DRG SUBMITTAL
G0.1
 Plotted On: 5/26/22

COVER SHEET

CABIN 1 & 3 EXISTING-DEMO & PROPOSED FIRST FLOOR PLAN

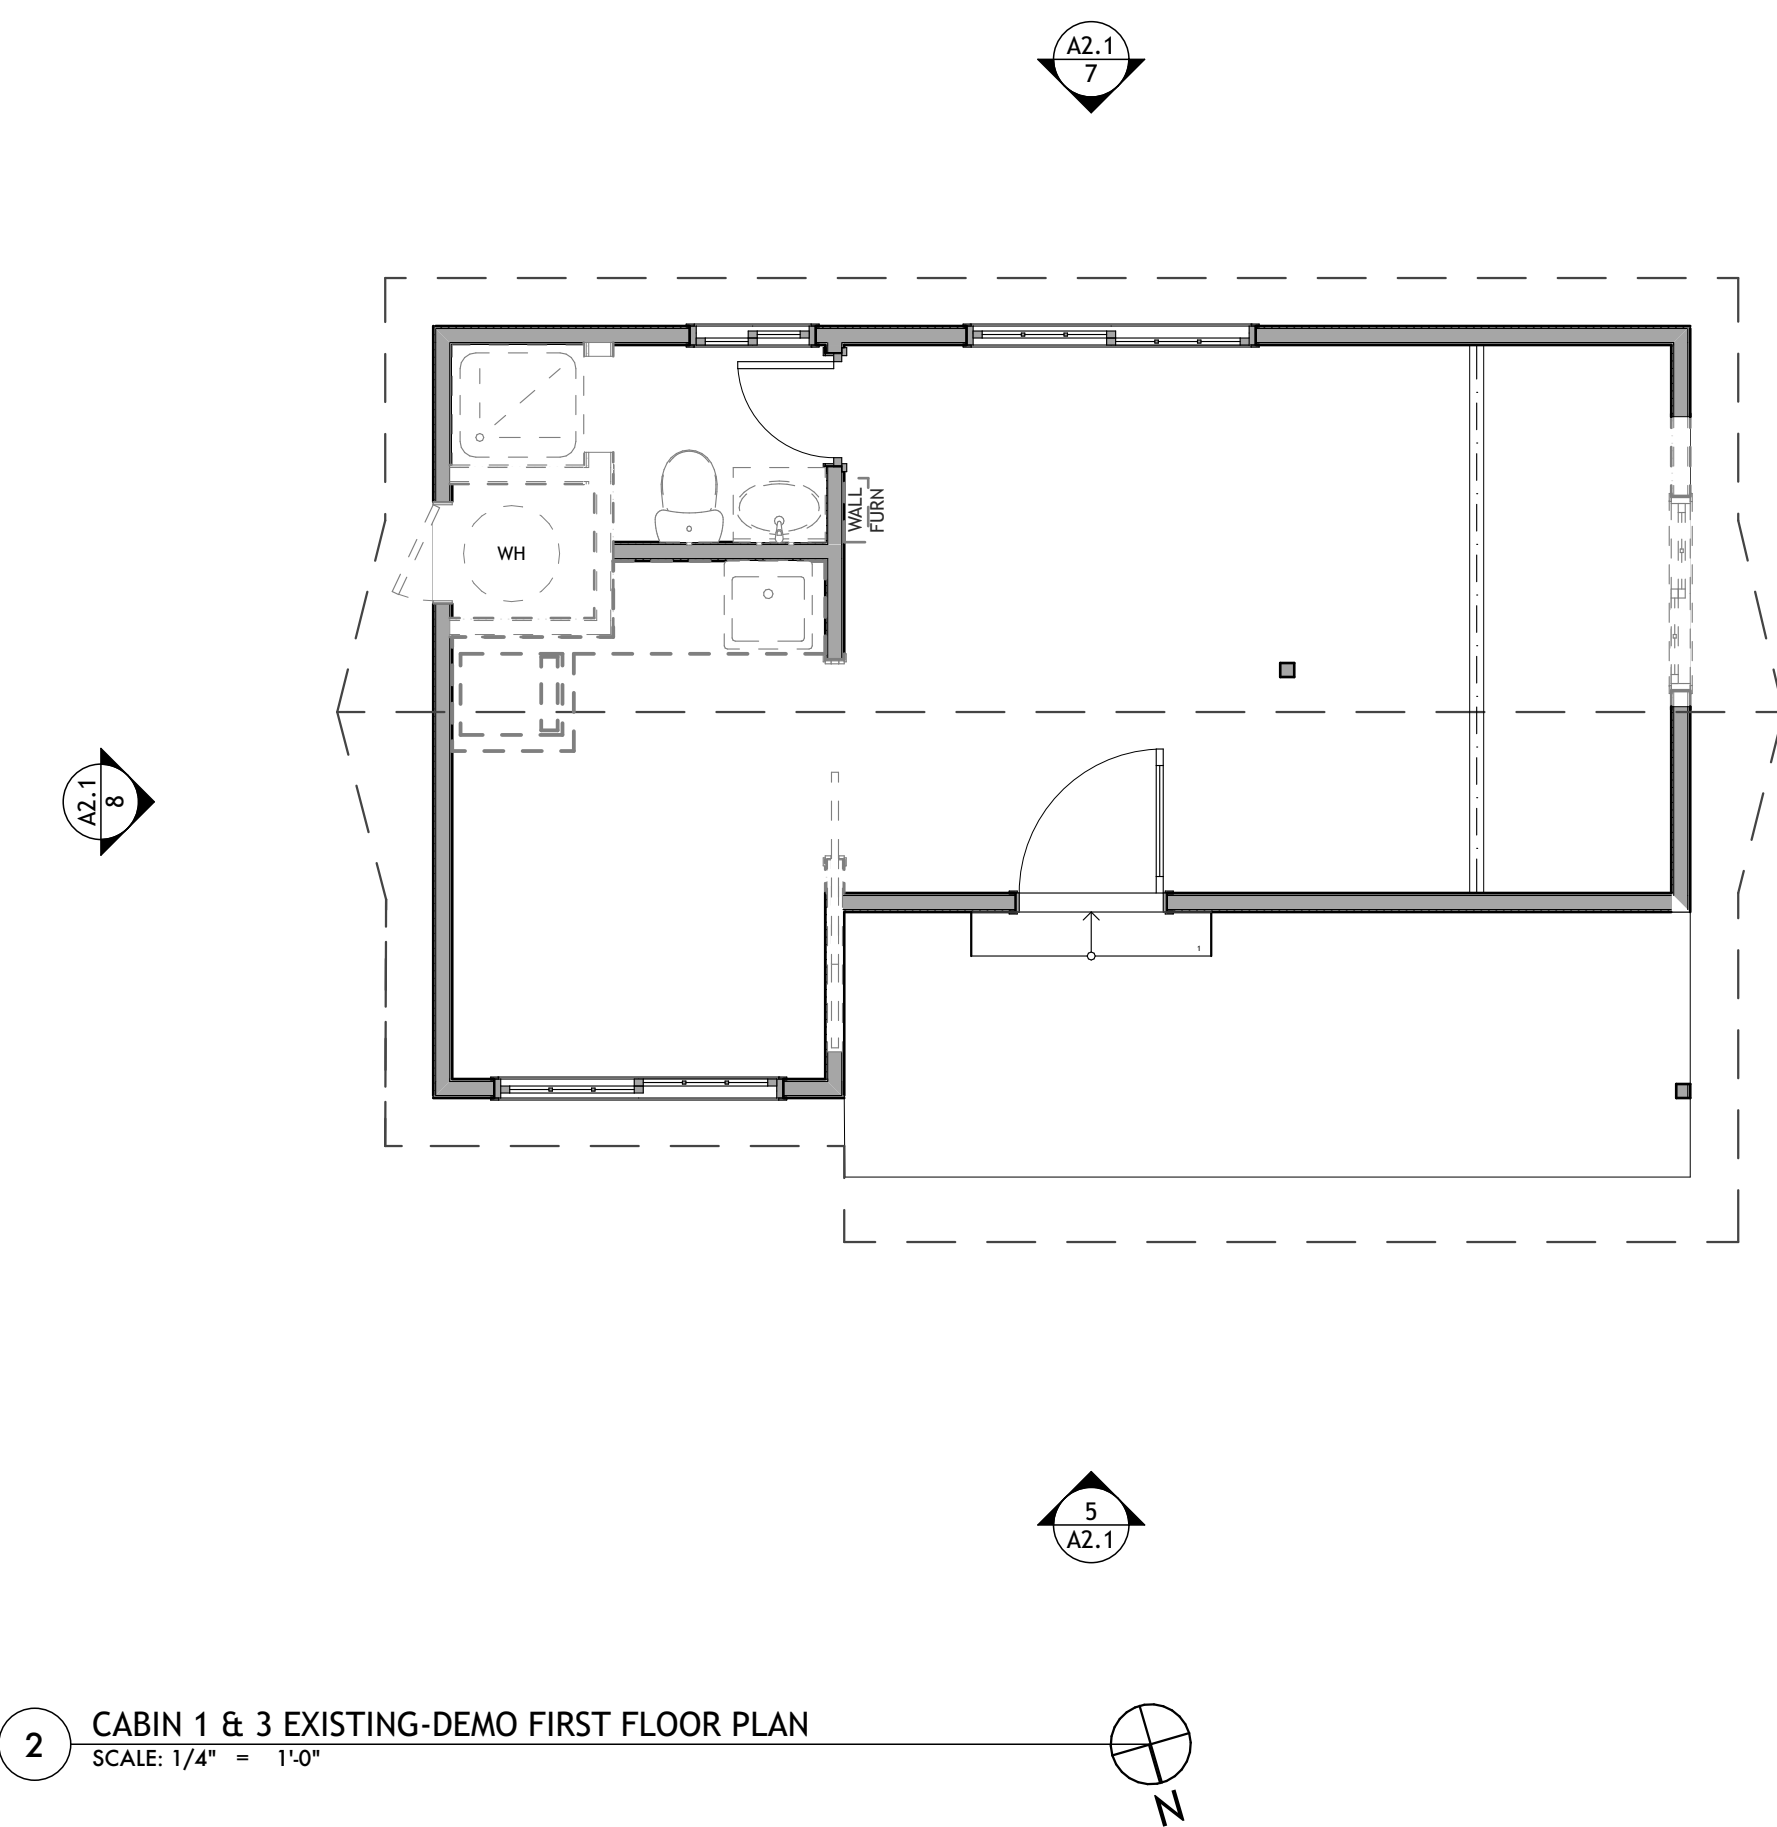
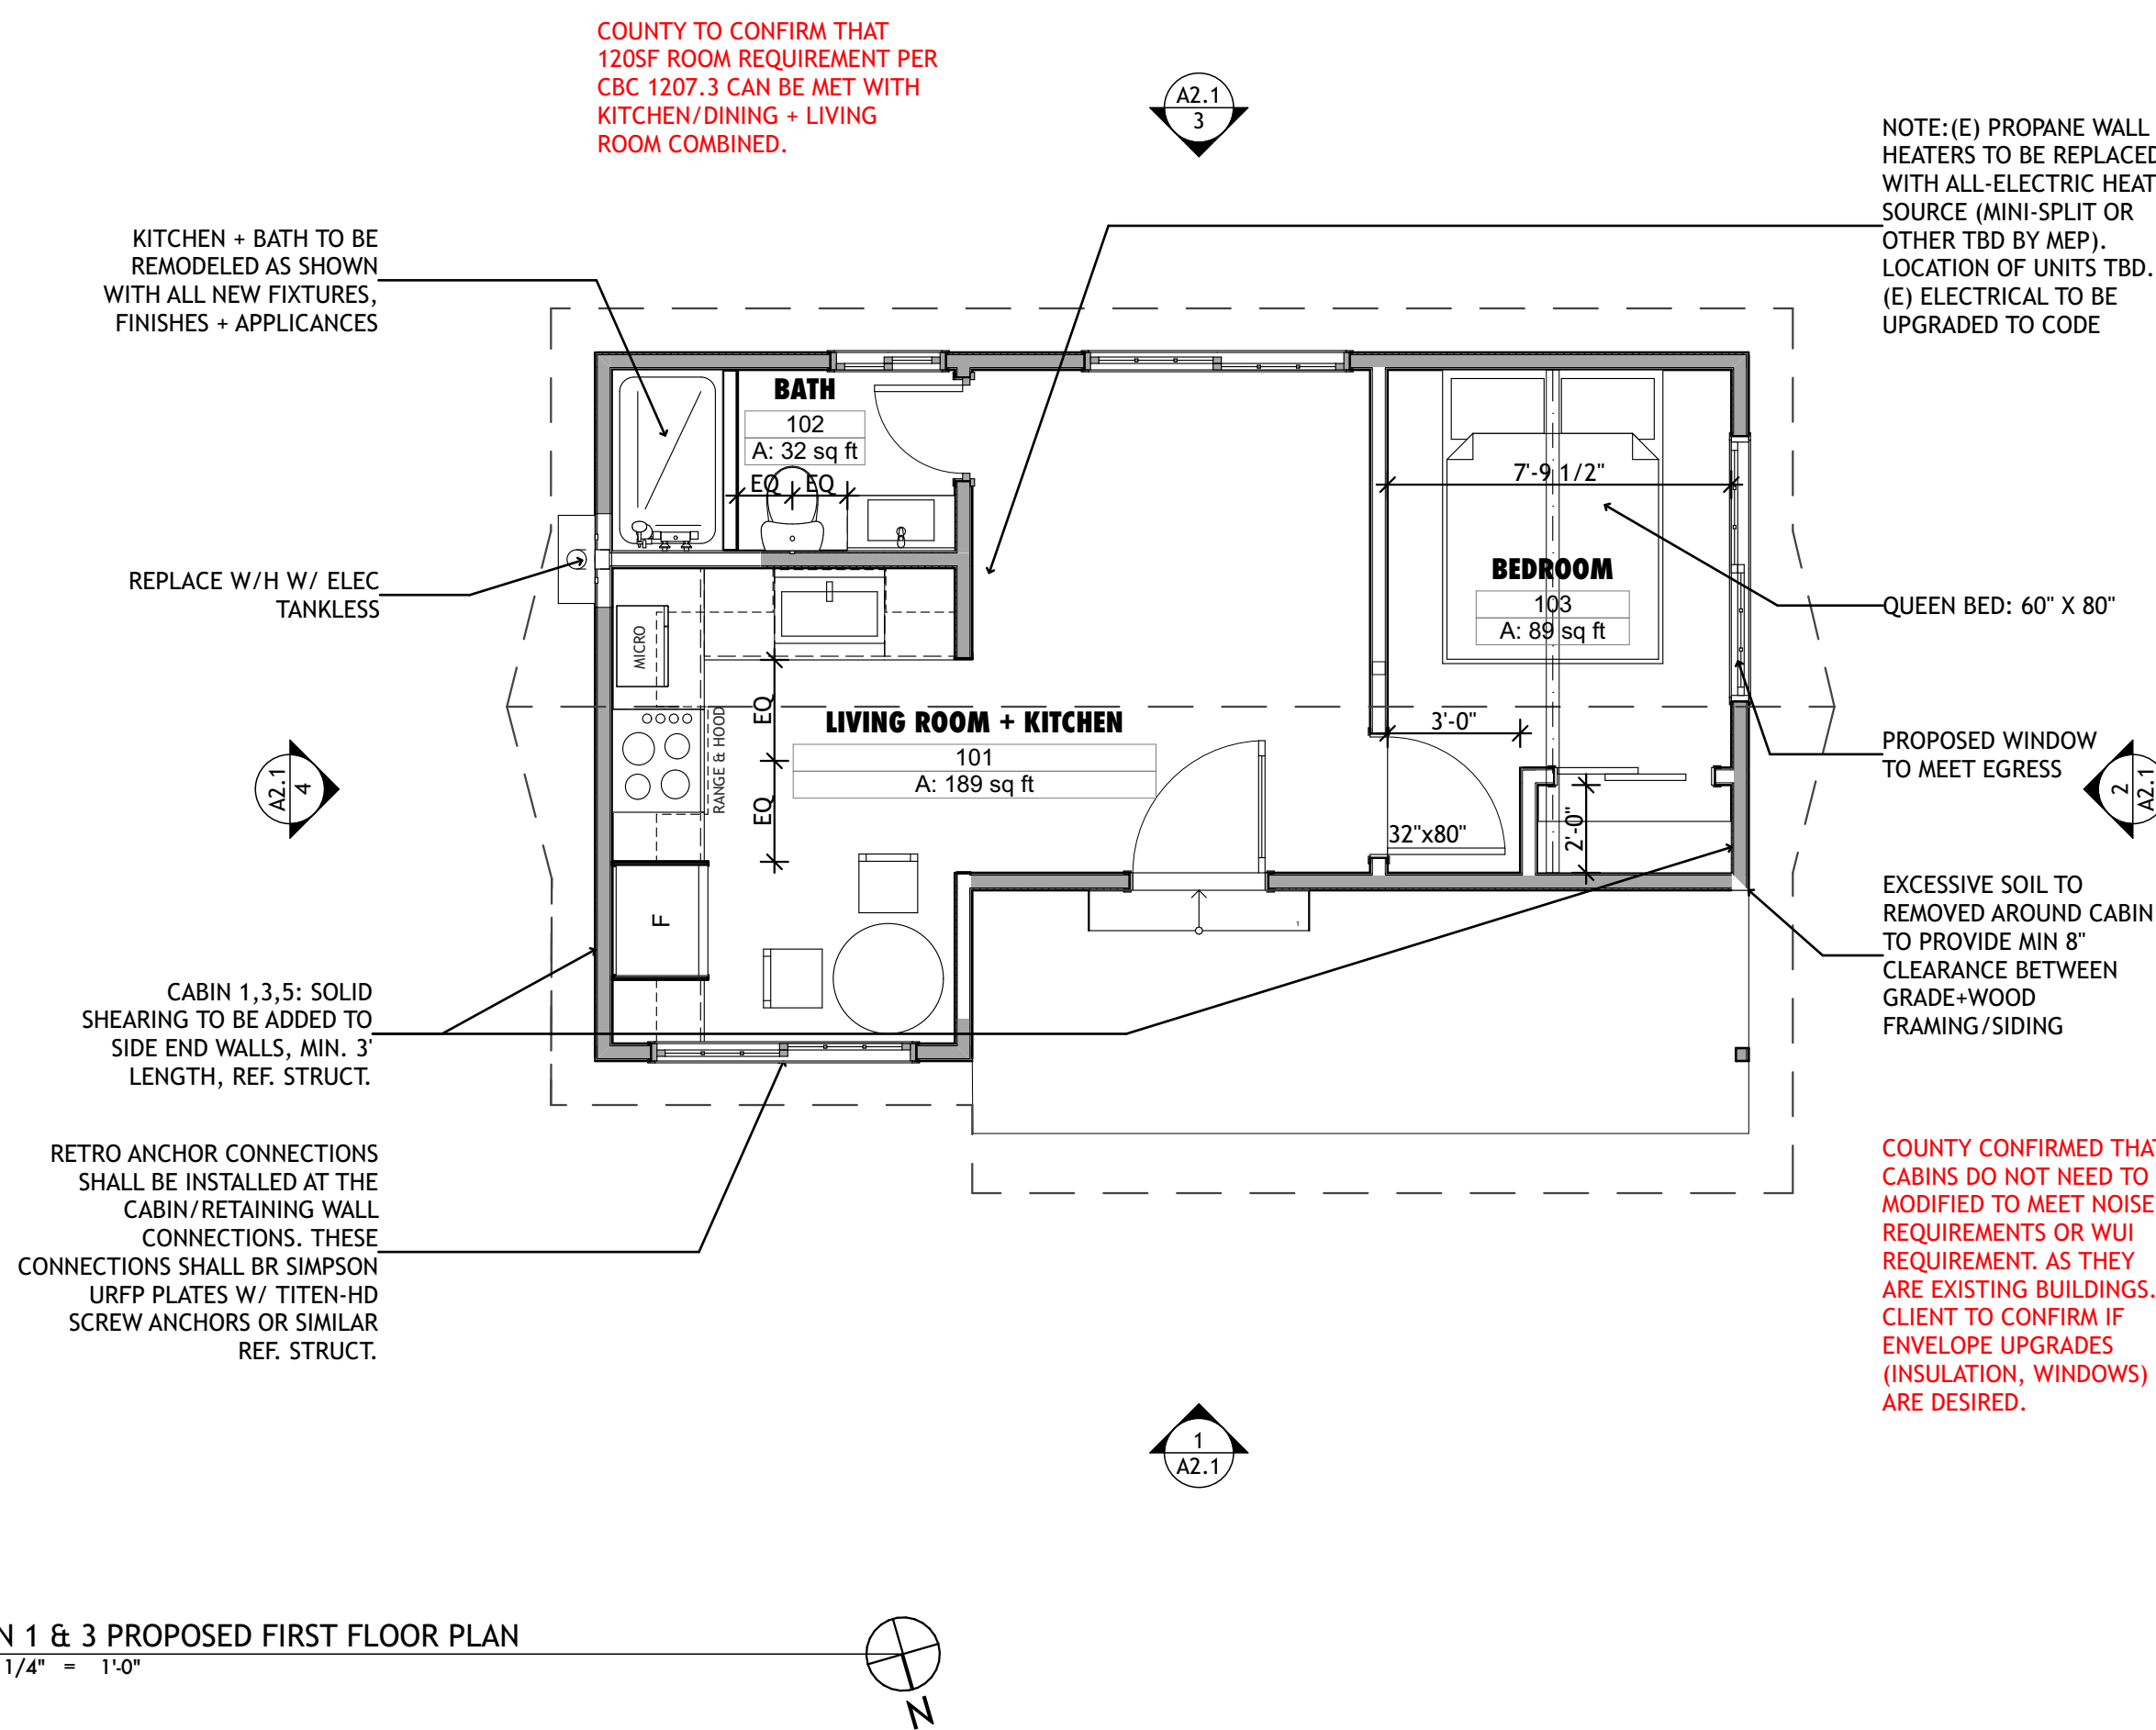
REPLACE W/H W/ ELEC TANKLESS

CABIN 1, 3, 5, SOLID SHEARING TO BE ADDED TO SIDE END WALLS, MIN. 3' LENGTH, REF. STRUCT.

EXCESSIVE SOIL TO BE REMOVED AROUND CABIN TO PROVIDE MIN 8" CLEARANCE BETWEEN GRADE + WOOD FRAMING/SIDING

COUNTY CONFIRMED THAT CABINS DO NOT NEED TO BE MODIFIED TO MEET NOISE REQUIREMENTS OR WUI REQUIREMENT, AS THEY ARE EXISTING BUILDINGS. CLIENT TO CONFIRM IF ENVELOPE UPGRADES (INSULATION, WINDOWS) ARE DESIRED.
